# INNER WEST COUNCIL

## DEVELOPMENT ASSESSMENT REPORT

<b>Application No.</b>	D/2018/25
<b>Address</b>	93 Louisa Road, Birchgrove
<b>Proposal</b>	Demolition of existing dwelling and associated structures and remediation of site. Construction of a new dwelling with basement parking provided with a car lift, landscaping and pool.
<b>Date of Lodgement</b>	18 January 2018
<b>Applicant</b>	F Bilotta
<b>Owner</b>	Mr F Bilotta and Mrs B Bilotta
<b>Number of Submissions</b>	Six
<b>Value of works</b>	\$1,464,000
<b>Reason for determination at Planning Panel</b>	Clause 4.6 variation exceeds officer delegation
<b>Main Issues</b>	Foreshore flooding Building location zone/bulk and scale Visual privacy View loss
<b>Recommendation</b>	Deferred commencement approval

upper ground floor plan

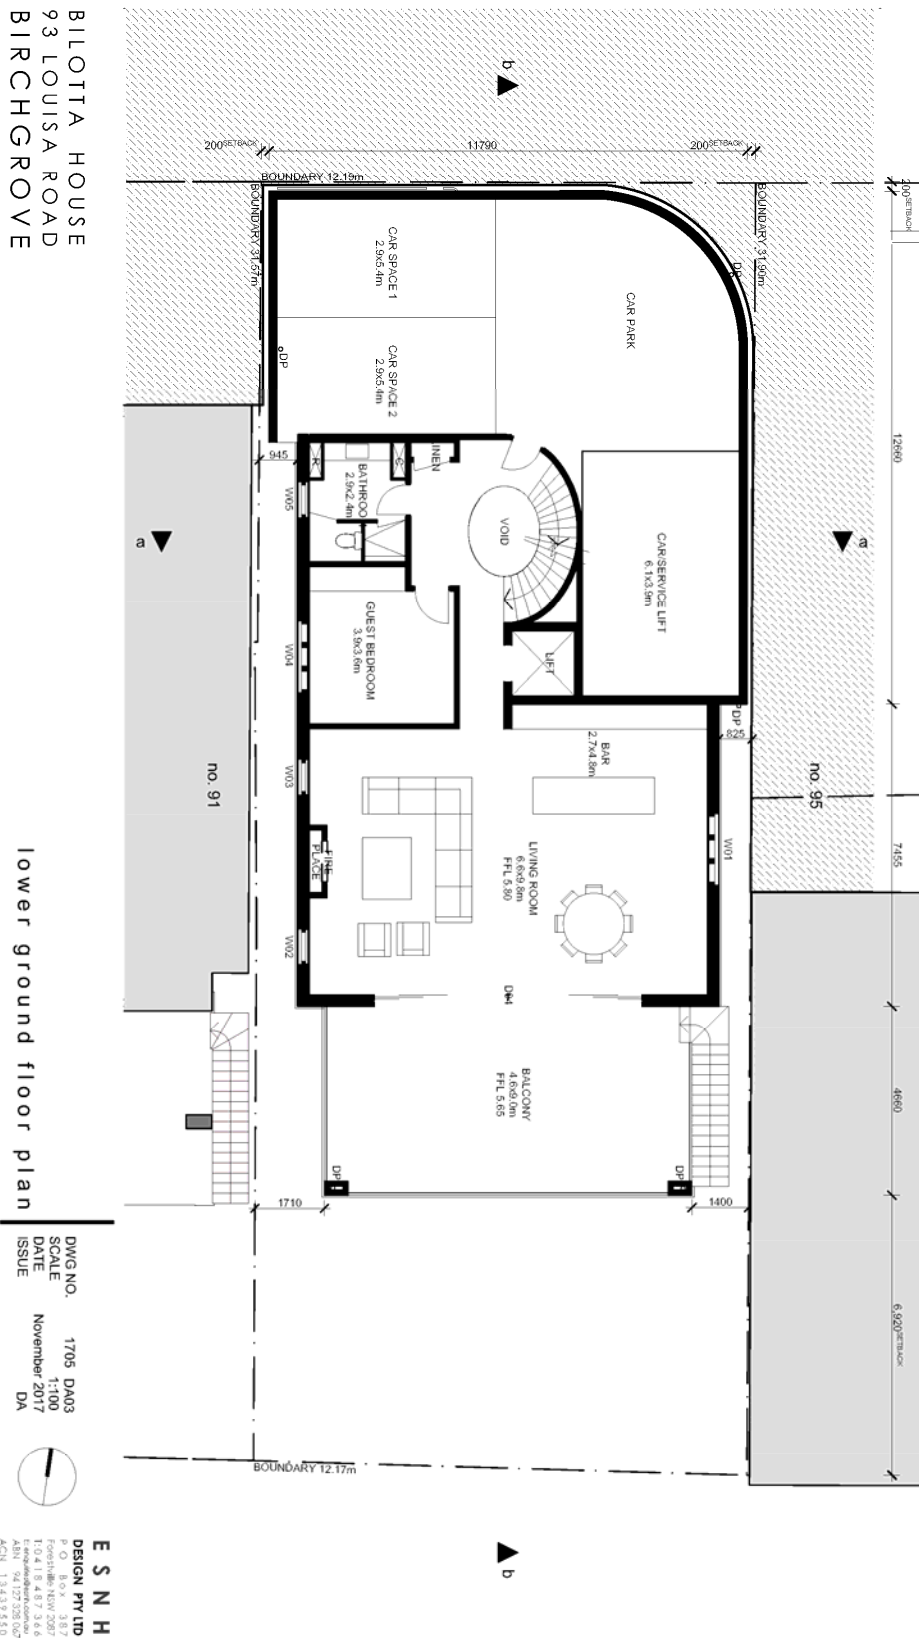
The proposal does not comply with point (a) in that the garage entrance door is in line with the study wall, these walls comprising the front wall of the main building of the dwelling. A central entry portico is located forward of the front wall and covers just over a third of the frontage. Although it would be possible to set the garage door back in line with the entrance door, increasing the length of the driveway and resulting in strict compliance with point (a) requiring this change would adversely impact on the symmetry of the design and not improve the streetscape appearance of the building. Less than half of the frontage of this dwelling is devoted to car parking and the garage is not considered to dominate the streetscape appearance of the dwelling. The objectives of the control are therefore met by the proposal.

is not agreed with. The development at 95 Louisa Road consists of two separate buildings, the dwelling fronting Louisa Road and the modified boatshed which fronts Snails Bay. While the proposal does not comply with the building location zone at any level, it is considered reasonable to align the rear extent of the proposed dwelling with the rear extent of the neighbouring dwellings at 87-91 Louisa Road as they are recent approvals and most similar in terms of lot depth. This will necessitate a condition of development consent requiring the upper ground floor to be reduced in depth by 1 metre to align with the rear alignment of the upper ground level of 91 Louisa Road, Birchgrove.

- d) The eastern wall of the car/service lift is to be set back an additional 170mm further west so that it is setback 410mm from the eastern boundary and aligns with the eastern garage entrance/kitchen wall on the upper ground floor plan and eastern wall of the first floor to provide reasonable access to the western wall of the dwelling at 95 Louisa Road if required for maintenance.

- e) The southern wall of the upper ground floor plan must be setback an additional 1 metre from the rear/southern boundary to align with the rear alignment of the upper ground level of 91 Louisa Road, Birchgrove.

first floor plan

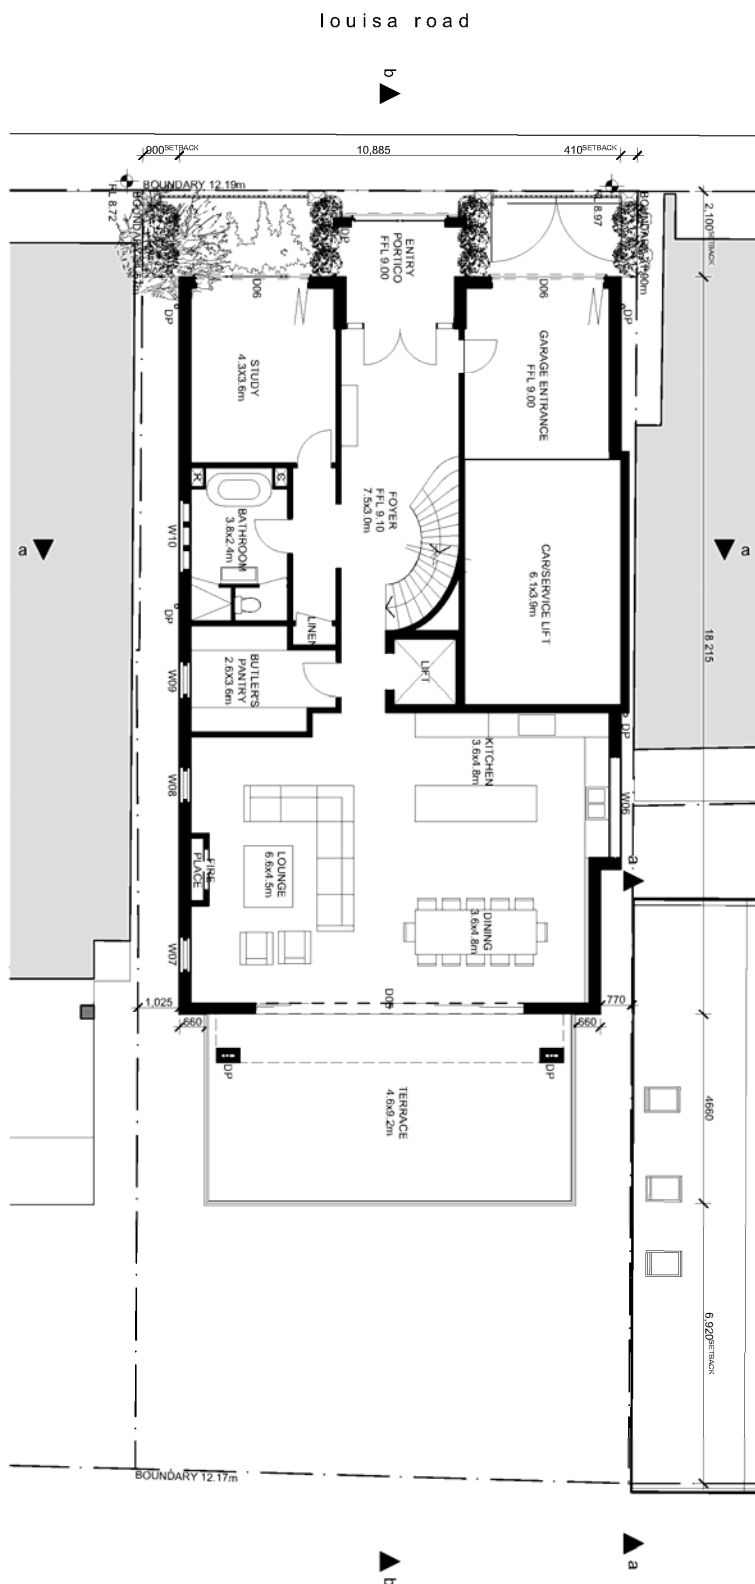
It is agreed that the upper ground floor balcony, first floor balcony and roof terrace at 91 Louisa Road have balustrades inset from the edge of the structure. This was not shown on the original plans but inserted on the amended plans. In order to address privacy impacts at upper ground level, a condition of consent will require the balustrade to be setback. The balcony at first floor level will be restricted in depth to approximately 1 metre and the balustrade or the roof terrace setback to match the equivalent balcony at 91 Louisa Road.

- f) The proposed rear facing first floor balcony is to be modified as follows:
    - i) The parts of the balcony to the east and west of the dwelling are not to be accessible. They shall either be converted to planter beds or a balustrade erected between the rear elevation of the dwelling and the southern edge of the balcony to prevent access to these areas.
